Subject: Westinghouse Owners Group  
Transmittal of Approved Topical Report, WCAP-15603, Rev. 1-A, (Non-Proprietary) "WOG 2000 Reactor Coolant Pump Seal Leakage Model for Westinghouse PWRs" (MUHP-6074)

**WOG 2000  
REACTOR COOLANT PUMP SEAL  
LEAKAGE MODEL FOR  
WESTINGHOUSE PWRS**

**SUBJECT: SAFETY EVALUATION OF TOPICAL REPORT WCAP-15603, REVISION 1,  
"WOG 2000 REACTOR COOLANT PUMP SEAL LEAKAGE MODEL FOR  
WESTINGHOUSE PWRs" (TAC NO. MB1714)**

Figure 2.2-1 Event Tree for RCP Seal Leakage Scenarios

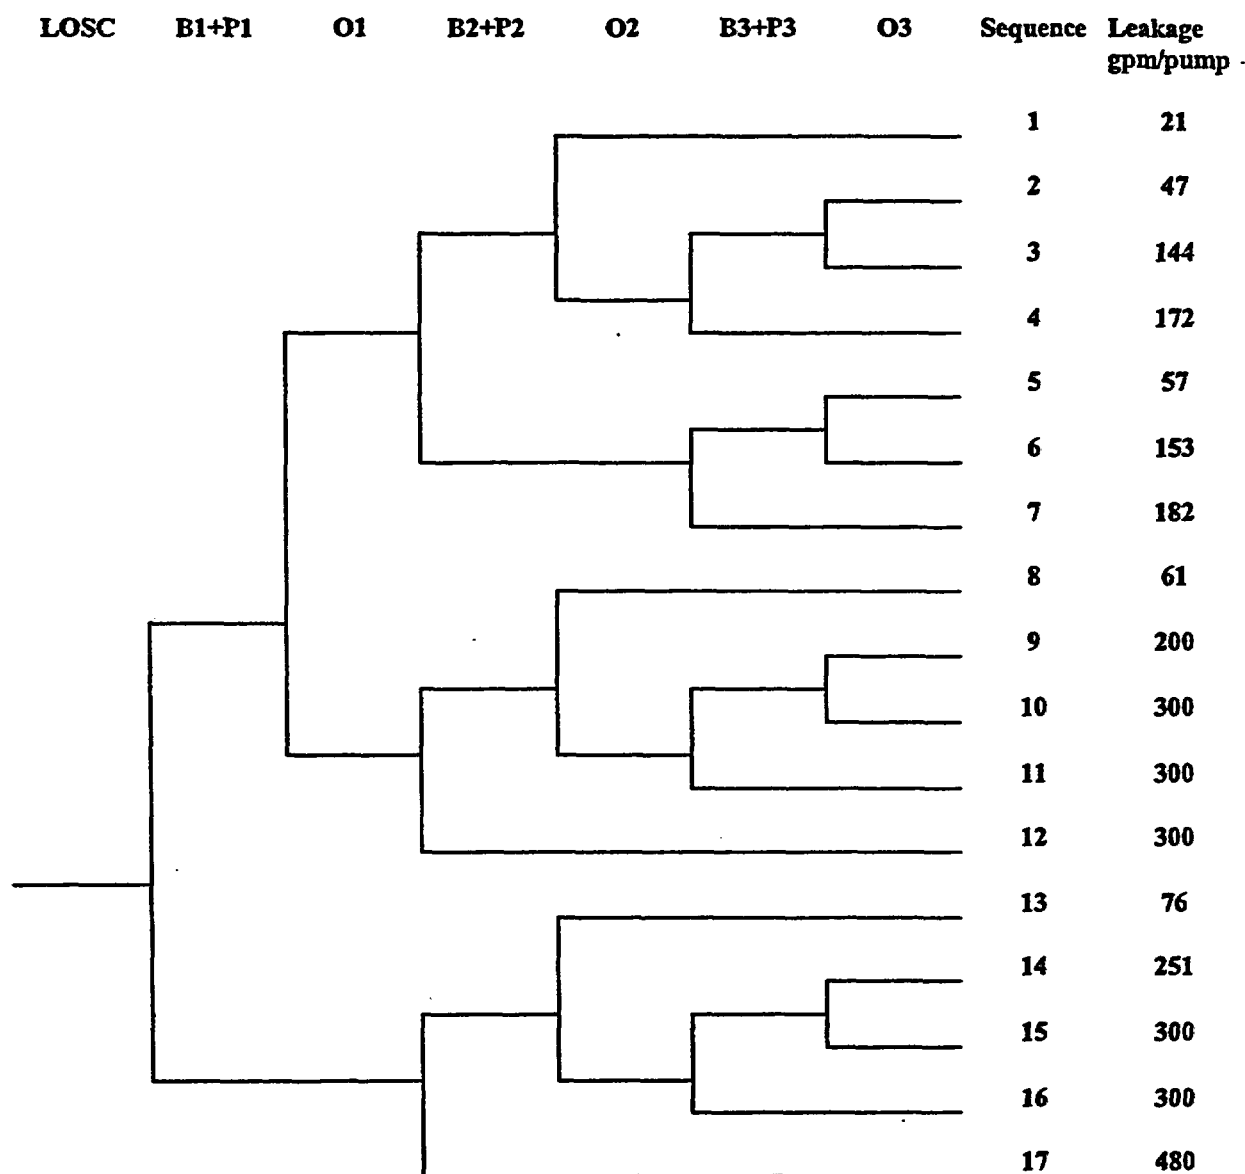
**RAI 8** The Chapter 4 discussion and results are not fully consistent with the RCP seal leakage event tree model presented in Figure 2.2-1. To be consistent with the Chapter 4 tables, there should be branch points in Figure 2.2-1 under the B3+P3 for each scenario path. Specifically, Scenarios 1 and 13 should be split to represent success or failure of the B3+P3 branch. This condition is reflected in the WOG 2000 model tables for the period,  $t$ , greater than or equal to 0.5 hours, but less than 2 hours. Likewise, Scenario 12 should be split to reflect " $t$ " greater than or equal to 2 hours, but less than 4 hours. For " $t$ " greater than or equal to 4 hours, Scenario 12 should be split further, for the B3 + P3 success branch previously split, under the O3 branch. Further, the associated scenario leakage rates need to be established for each of these additional scenarios. The leakage rates for Scenarios 1b and 13b (failure of B3 +P3) need to be established or justified as remaining at the rate for the success path. Likewise, the leakage rates for Scenarios 12a (success of B3 + P3) and 12b (failure of B3 + P3) need to be established or justified. This justification is needed because these branches come from Scenarios 5 and 7, respectively, which have different leakage rates of 57 gpm and 182 gpm, respectively. Finally, the leakage rate for Scenario 12aa (success of B3 + P3 and O3) needs to be established. Should the rate be 251 gpm (similar to Scenario 14 conditions) or 300 gpm?

**Response to RAI 8:**

*Chapter 4 of WCAP-15603 deals exclusively with old o-rings. All domestic Westinghouse nuclear power plants have either switched to qualified o-rings, or are scheduled to do so in the near future. Since the old o-rings are no longer used, we have removed reference to old o-rings from WCAP-15603. For any plants with old o-rings, this will be handled on a case-by-case basis.*

Figure A-2 BNL Best Estimate Model (Qualified O-Rings)

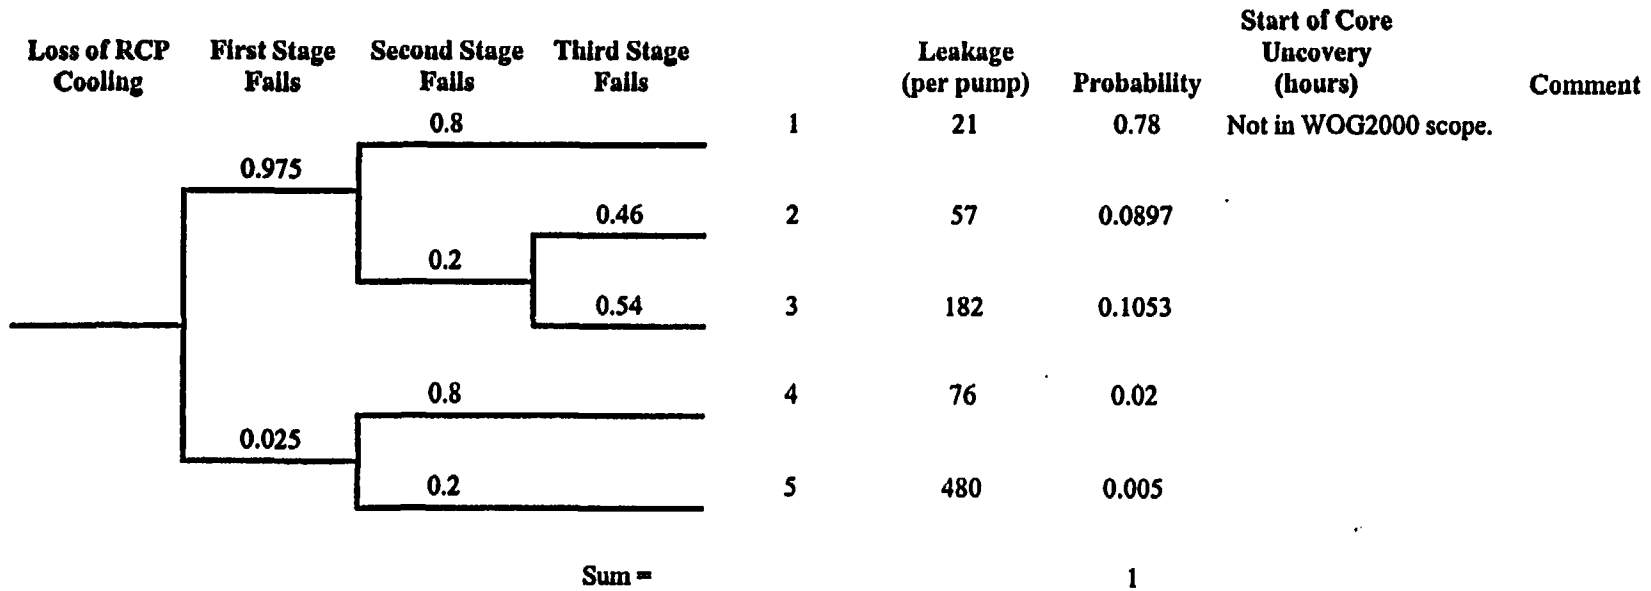
**RAI 1** The Topical Report states in Section 1.0 (page 1-1) that the Brookhaven National Laboratory (BNL) model is the current regulatory model for reactor coolant pump (RCP) seal leakage, and it uses this model as the starting point for the development of the WOG 2000 model. However, the BNL model is not the current regulatory model. The staff committed in resolving Generic Issue 23 to use the Rhodes model until other acceptable reactor coolant pump (RCP) seal models were developed. The original intent of the BNL report was to interpret and clarify the other existing RCP seal models, including the Rhodes model. However, as part of their report, BNL developed their own best-estimate RCP seal model, which differed from the other seal models. In developing the BNL best-estimate model, BNL made assumptions regarding seal failure with which the U.S. Nuclear Regulatory Commission (NRC) staff may not fully agree. For example, the Brookhaven model uses a probability of 0.54 for the popping-and-binding failure mode for the third-stage seal, given that the second stage seal has failed, and the WOG 2000 model reduces this probability to 0.27 for the “new” o-rings. However, the Rhodes model assumed pop-open failure of the third stage seal under these conditions (i.e., probability of one). The Topical Report needs to address and justify the differences between the WOG 2000 model and the Rhodes model.

*The sentence mentioned in the RAI will be modified in WCAP-15603 to describe the BNL Report as the “primary reference” for the WOG2000 model.*

*The basis for considering the BNL Report as the primary reference is that (a) it contains a best estimate RCP seal Leakage PRA model and (b) it represents the most current effort to provide a reasonable middle ground for this expert-opinion-driven issue. In our opinion, the ‘Rhodes Model’ represents one opinion, a conservative one at that, which may have been adequate for generically addressing the USI 23 (the purpose of NUREG /CR-4906P and NUREG/CR-5167), but is not appropriate for plant PRA modeling and decision making. Foundational to PRA*
